From: CuadradoDeJesus, Samuel
Sent: Thursday, October 06, 2011 4:16 PM
To: custerc@firstenergycorp.com
Cc: dorts@firstenergycorp.com; Davis-BesseHearingFile Resource
Subject: FW: Davis Besse - External Moisture Barrier - IWE Inspection Requirements
Attachments: IWE requirement for moisture barriers.pdf

The attached IWE requirements are the basis for the staff position on RAI B.2.22-5.

FIG. IWE-2500-2 EXAMINATION AREAS FOR MOISTURE BARRIERS

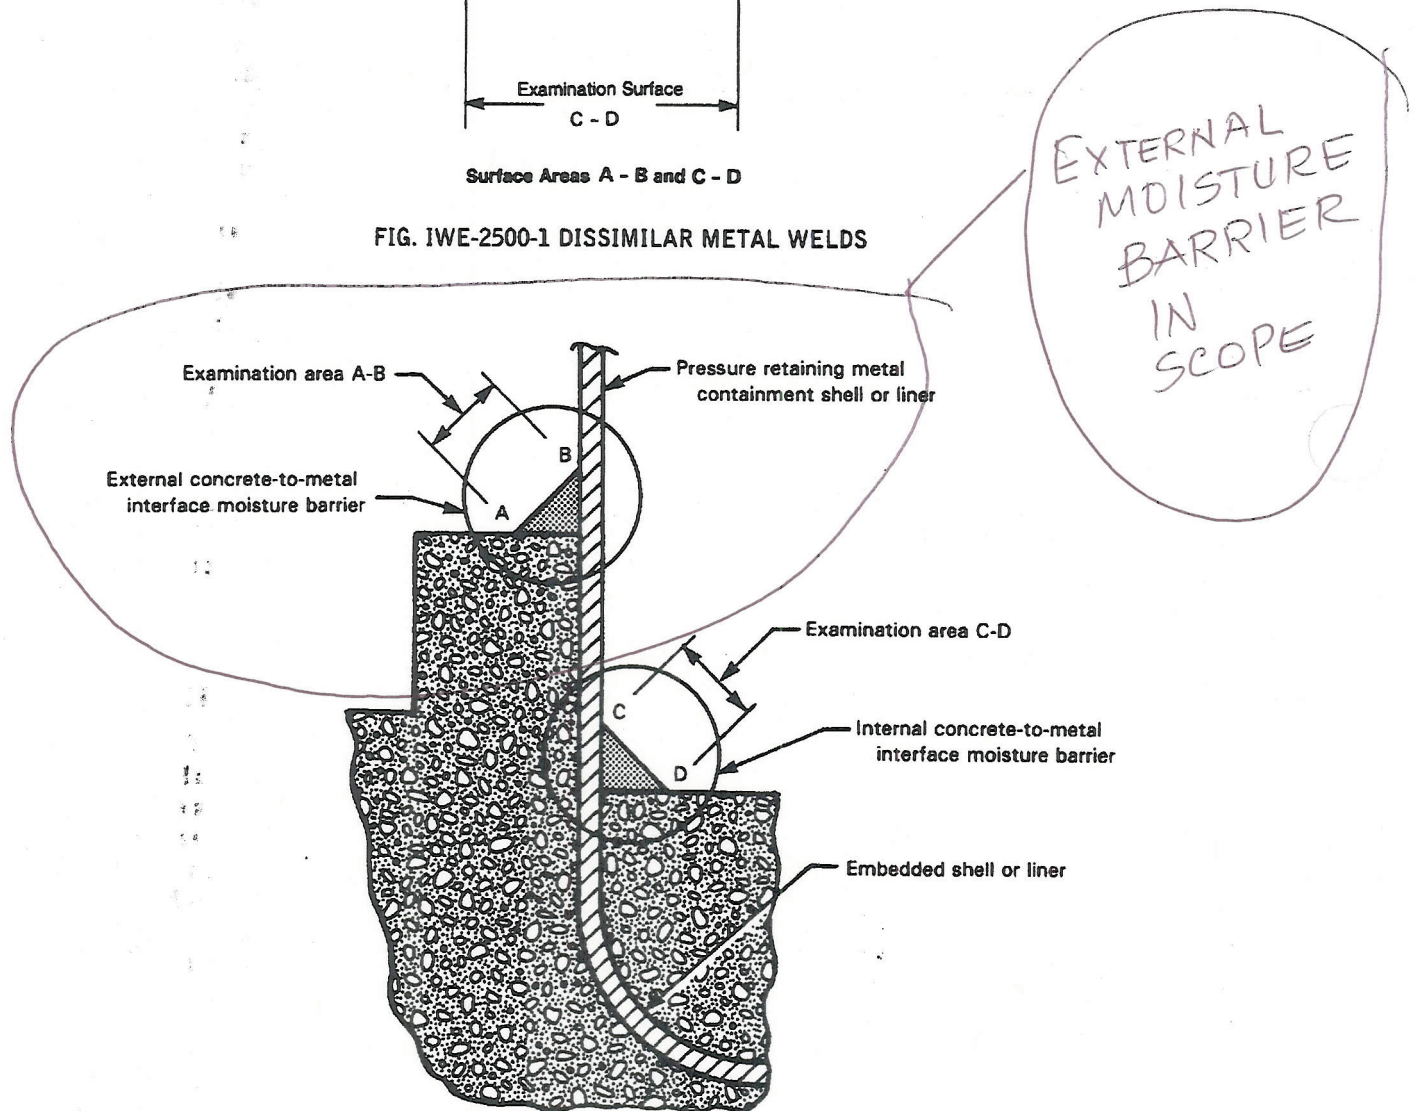
DEFECTIVE/DEGRADED
MOISTURE BARRIER
TO BE REPLACED
(STANDARD PRACTICE)
& CODE
REQUIREMENT

EXTERNAL & INTERNAL MOISTURE BARRIER
